Report Title: 19/03731/FUL: Mrs D MacGregor

Land 60M NW of Achnasol House, Achnabobane, Spean Bridge

Description: Erection of house (retrospective amendment to planning permission

17/05834/FUL)

Amended Elevation and Plan

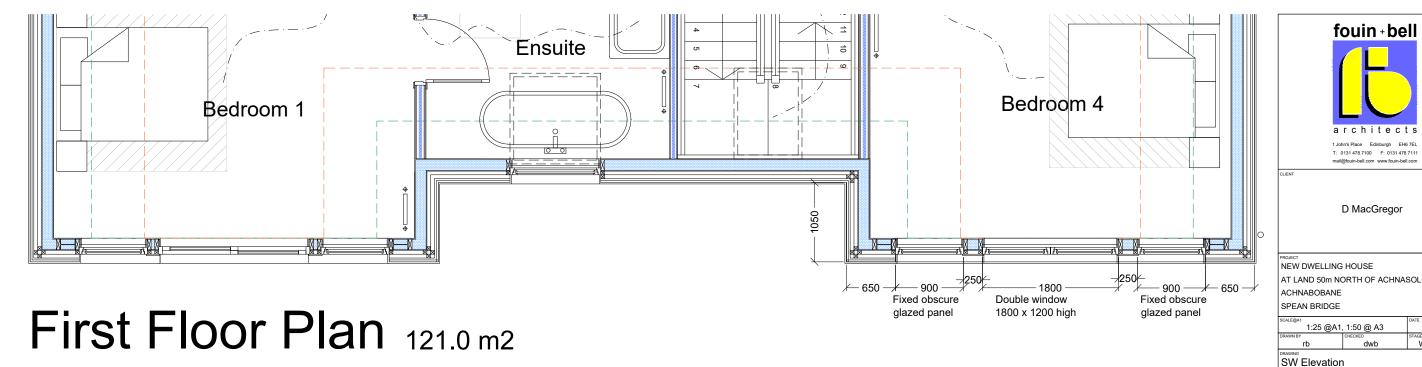
- 2.1 An amended plan was submitted on the 20 December 2019. The agent has summarised the changes as follows:
 - 1. The glazed "balcony" is removed in its entirety as requested.
 - 2. The proposed double doors are removed and amended to a window with fixed light below.
 - 3. The side panels and panel under the window will be installed in obscure glass, in line with the recommendation set out within the original Report.

3.1 The revision to the elevation does now result in a slight imbalance in the design of the rear elevation of the property. However, it is relatively minor overall. It is considered that the revisions are sufficient to address the issues raised at the South Planning Applications Committee meeting on 04 December 2019 with regard to the amenity of the neighbouring occupiers, in particular through the removal of the balcony and doors. The main window element is not proposed to be obscure glazed, however given the reduced size, the obscure glazing of the other elements, the removal of the balcony and the screening already planting, this is considered to be an acceptable solution.

1. The house hereby approved shall not be occupied until the upper floor windows and doors on the south facing gable of the eastern wing have been amended in accordance with drawing number 19-103 PL10 A dated Dec 19. Full details of the type of obscured glazing to be installed in these windows shall be submitted to, and approved in writing by, the Planning Authority prior to the installation of the obscured glass. The windows/fixed panels identified as 'obscure glazed' on drawing number 19-103 PL10 A shall be glazed with the approved obscured glass prior to initial occupation of the house and thereafter shall be retained with the approved obscure glazing in perpetuity.
